Req 437 (d): the short-cut stair behind the hillside tapestry

Model version 26. The tapestry on the corridor's outer wall (0.45 m) opposite the inglenook, x 59.5. Gold box: recommended.

2: a straight stair in the wall, built out

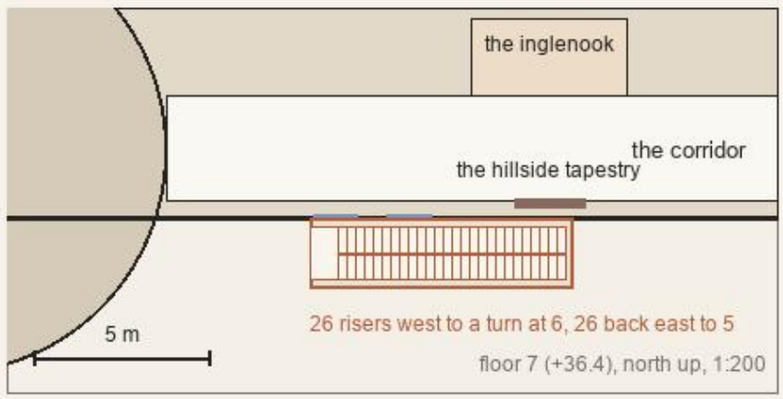
2: the face built out 2.0 m from x 52.7 to 60.2, 5 to 7, the flights straight (Filch's look up the stair in GoF 25), a dogleg of two lanes side by side, but a slab 7.5 m long and 2.0 deep hung on the face for two floors, and it blinds the corridor's two built windows (run east instead, it blinds the landing's window).
